CITY OF ALBUQUERQUE

Re: Starbucks, 700 Juan Tabo NE
Preliminary Grading Plan
Engineer's Stamp Date –no stamp- (K22/D006B)

Date: 11.19.14
To: Curtis Cherne, P.E., Hydrology
From: Jay Newell, P.E.
RE: Starbucks – Juan Tabo & Copper; Project #1003777
Hydrology Formal Comment Responses

SHEET TITLE:
PRELIMINARY GRADING PLAN

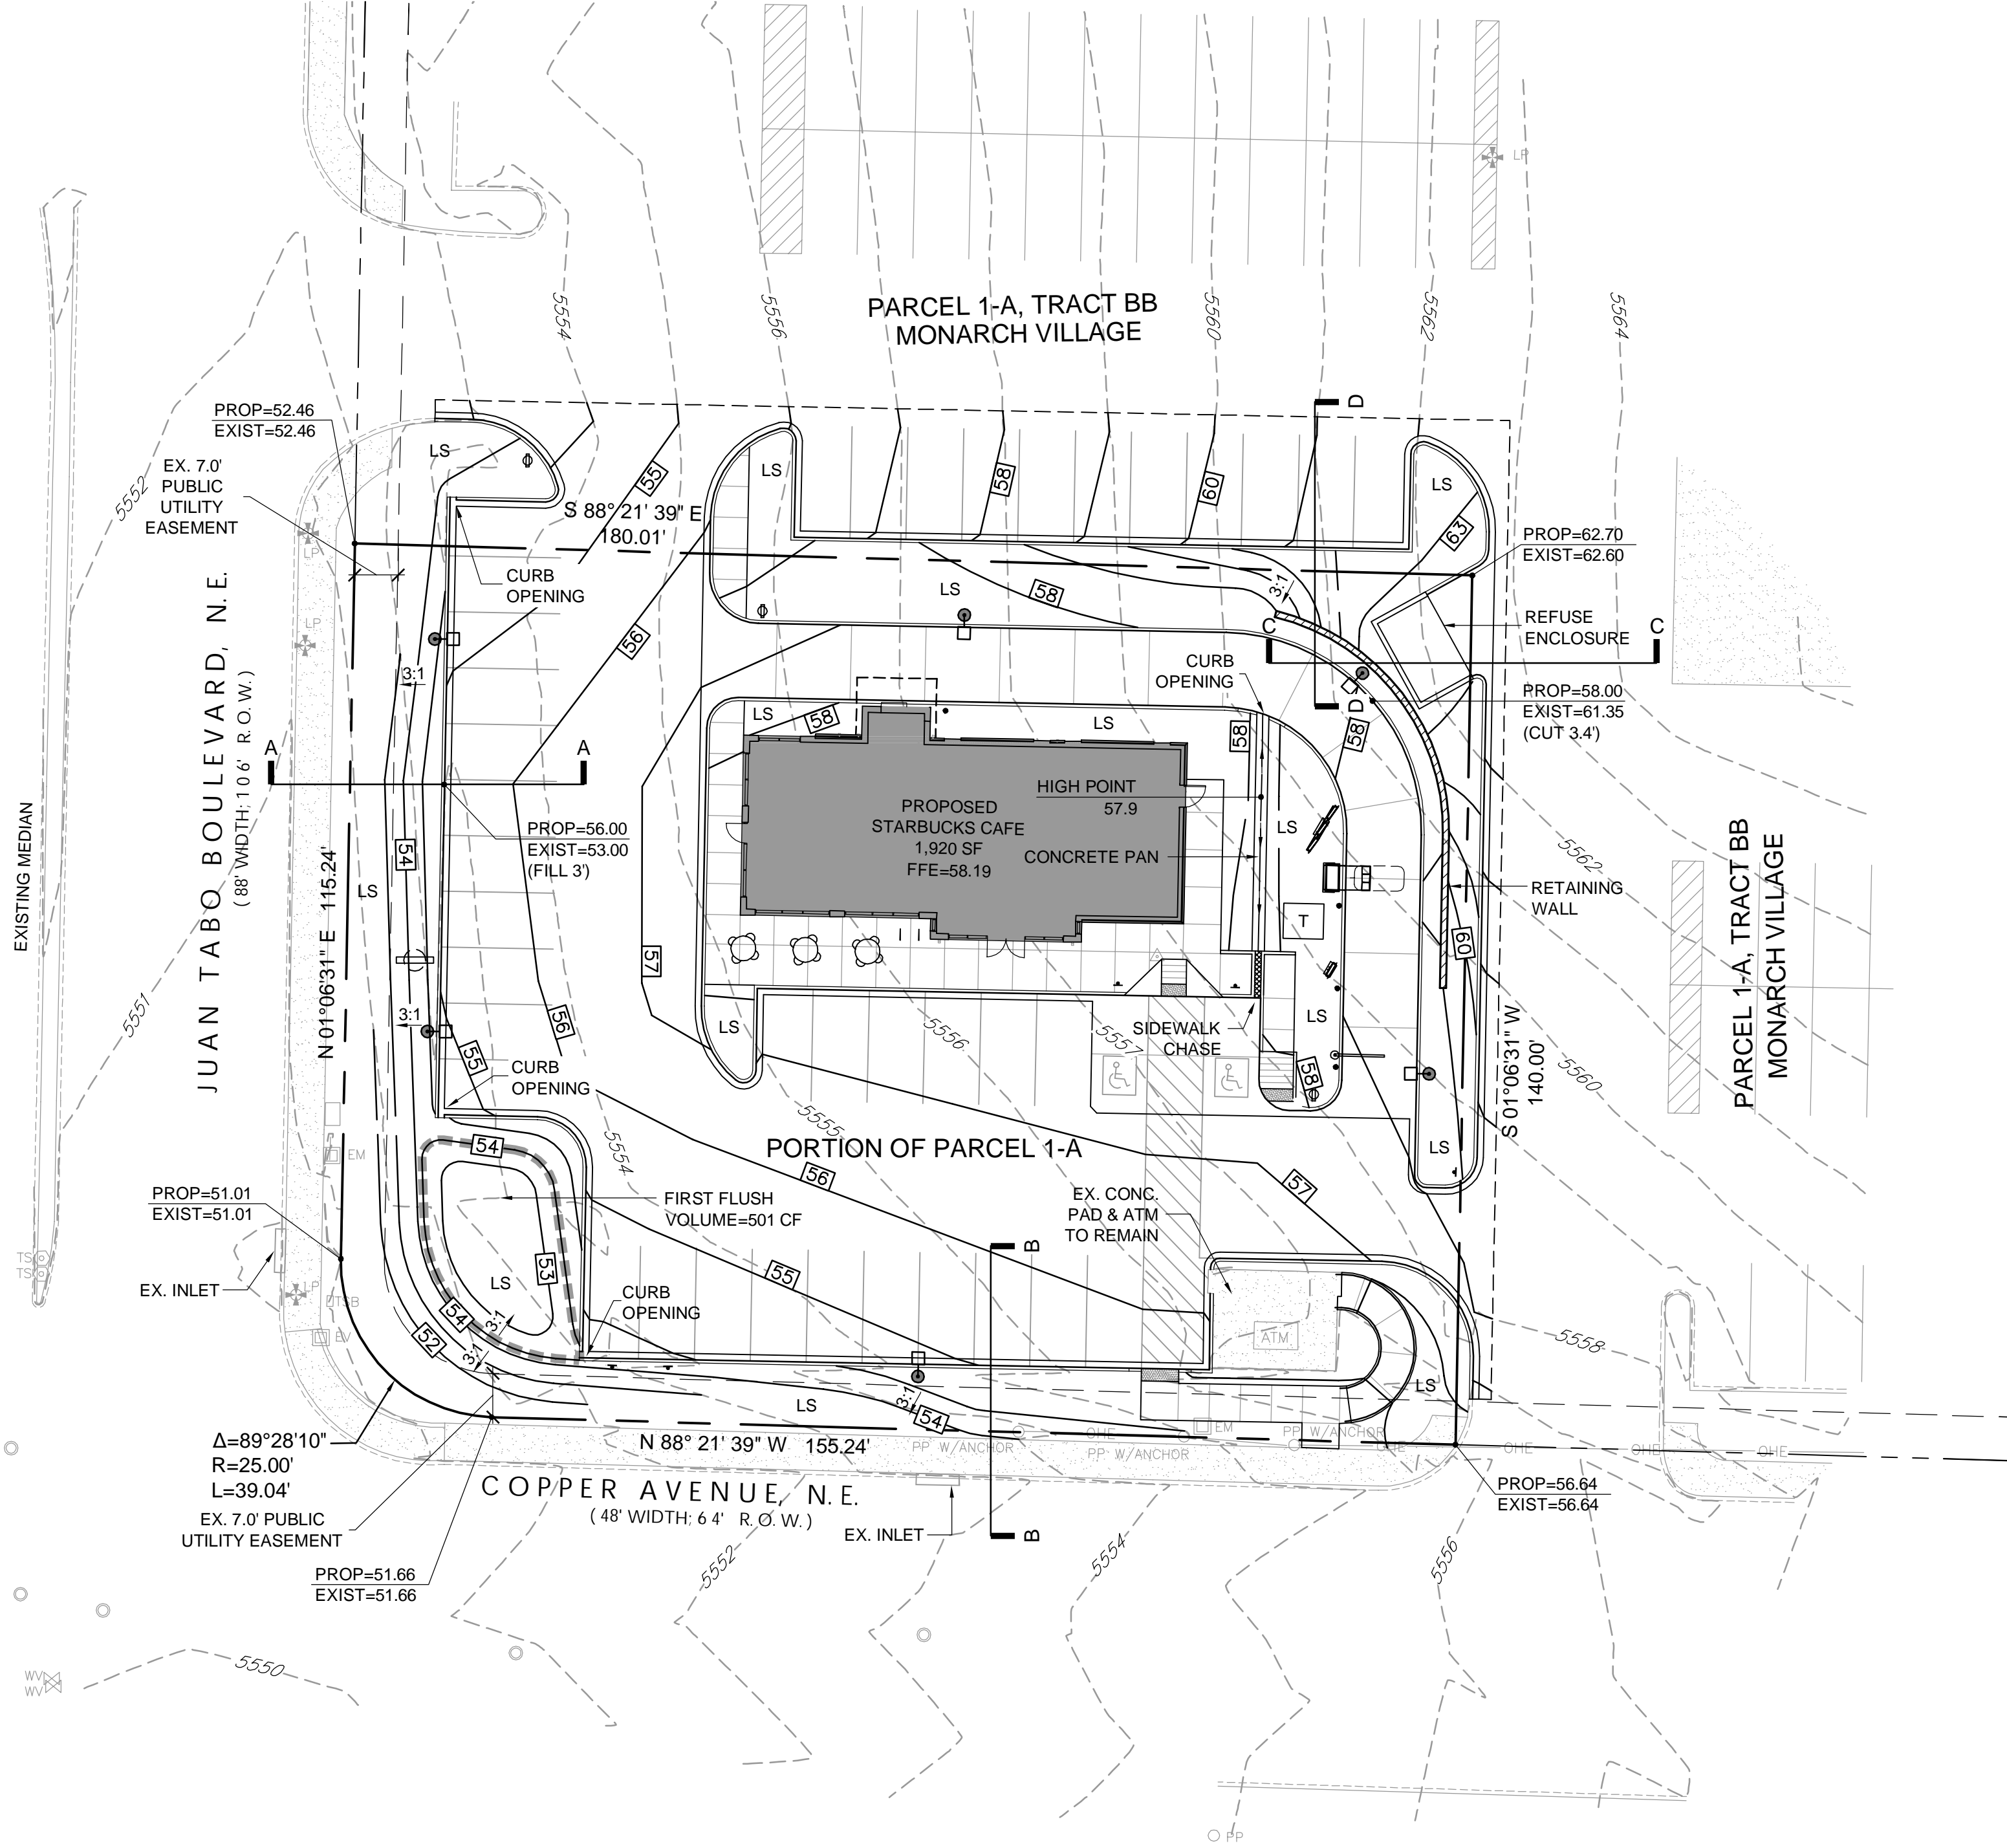
- Specify the width of the curb openings. A detail may be helpful if the sides are tapered.
- The refuse enclosure is to drain through a sand filter then to the sanitary sewer.
- It appears the site does not fit on the proposed lot. If construction is to occur on the adjoining lot, written approval from the adjoining lot property owner is required or the proposed lot could be bigger.
- Please include the word "drainage" in the Sheet Title (e.g. Grading and Drainage Plan).

2. The site plan shows proposed property lines. Since a platting action will be required, this site plan should be processed concurrently with the platting action at DRB.

3. In general, sites in Albuquerque are to accept offsite flows and all plans must state how the site will manage the first flush. Submit a conceptual grading plan to Hydrology that includes a narrative that describes the project as well as addresses the comments provided above for DRB approval.

The revised grading plan included with this re-submittal has a revised narrative (see the upper left corner of the plan) describing the project and drainage design.

As discussed by phone on 11.17.14 with Mr. Cherne, minimal off-site flows impact the site. The majority of off-site flows are conveyed in the proposed curb and gutter at the project site's north and east sides through existing drive entrances to the overall shopping center; and are discharged directly to the surrounding public street drainage system in their historic manner. The refuse enclosure is the only on-site area tributary to the off-site shopping center.

First flush calculations (included on the plan) indicate a required volume of 497 cf (based on 17,543 sf of impervious area on the proposed lot). The grading plan indicates a pond of volume 501 cf in the landscape area at the southwest corner of the site. Two curb openings convey a portion of the proposed lot's runoff to the pond. A third curb opening at the northwest corner of the site conveys a portion of the proposed lot's runoff across the adjacent landscaped island and to the existing public street system in Juan Tabo Boulevard, N.E. As discussed by phone, providing a first flush volume in this area is constrained by the proposed slopes and minimal available area. As an alternative, providing volume in the landscaped area immediately north of the proposed drive-through lane was explored. The adjacent parking to the north slopes significantly from east to west, resulting in a low point and associated curb opening entrance to the alternative pond below the attainable ponding elevation. In addition, even with 3:1 slopes, the narrow aspect of the landscaped area does not afford significant volume. Subsequently, parking stalls at the proposed site's southwest corner were removed to make room for the entire volume in this location.

The first flush pond will discharge across the adjacent landscaped area and to the existing public street system in Juan Tabo Boulevard, N.E. and Copper Avenue, N.E. Major storm runoff will follow similar patterns to those described for the first flush.

In addition to provision of the first flush volume, it should be noted that the site's existing impervious area (as parking for the overall shopping center) is 20,942 sf; and that the proposed site reduces this impervious area to 17,543 sf representing a 16-percent reduction in impervious area. Parking islands and landscape areas immediately adjacent to the proposed lot reduce the existing overall shopping center impervious area by an additional 864 sf.
